AGENDA
PLAN COMMISSION
Tuesday, September 8, 2020 at 6:30 p.m.

SUBJECT: Review of Applications for a Rezoning and Site Plan for Lot 1 on Falcon Ridge Drive

To: Kristine Anderson, Plan Commission **Date:** September 2, 2020
From: Greg Governatori
CC: Carina Walters, Megan Watkins, Gregory Guidry, Peter Riggs, Tanya Fonseca,
Subject: Falcon Woods Amended Review

TITLE SHEET

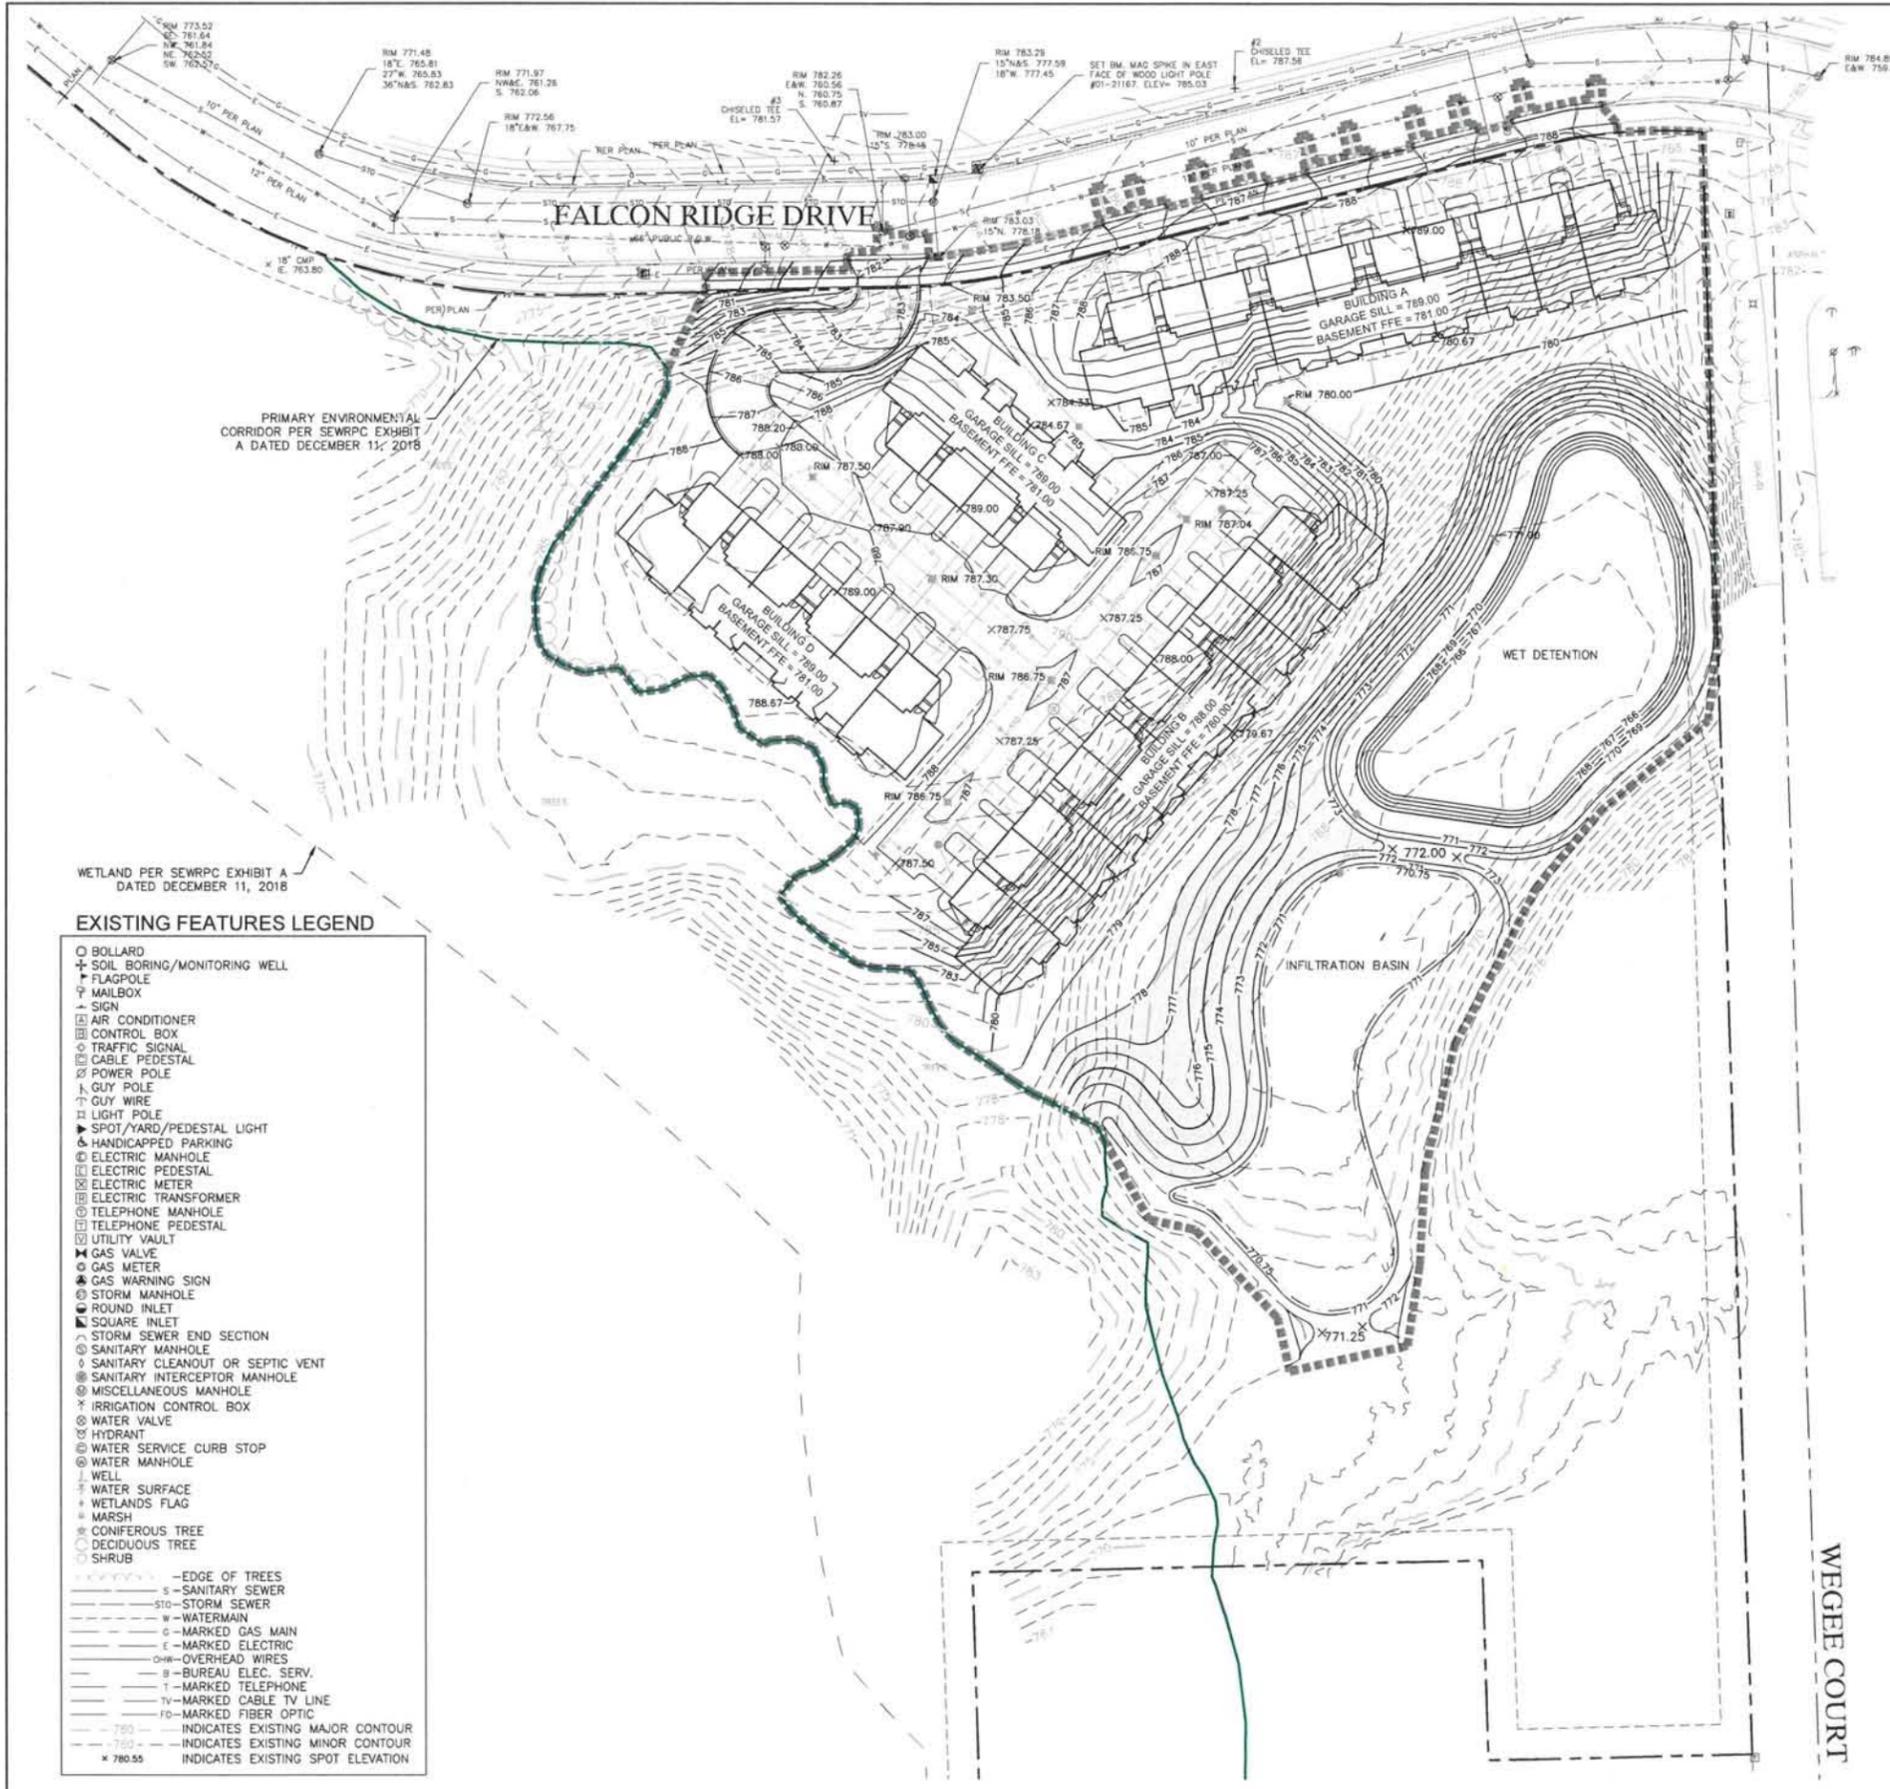
1. A condominium plat was not included as part of the site plan approval application. A condominium plat is required showing all easements reserved for public sanitary sewer, water main, and storm water facility improvements and access.

3. Storm sewer sizing and flow calculations are required, along with all pipe data included on the plans.
4. The storm water and infiltration basins are required to be certified once excavated to final grade. The city shall be notified at the time of completion for final acceptance and certification. The as-built Data shall be provided to the city in digital format for inclusion in the city-wide system mapping.

5. The public watermain and sanitary sewer mains require plan and profile sheets for review. The sheets shall include all required construction information, including pipe size, materials, stationing, bends locations, slopes, elevations, etc.
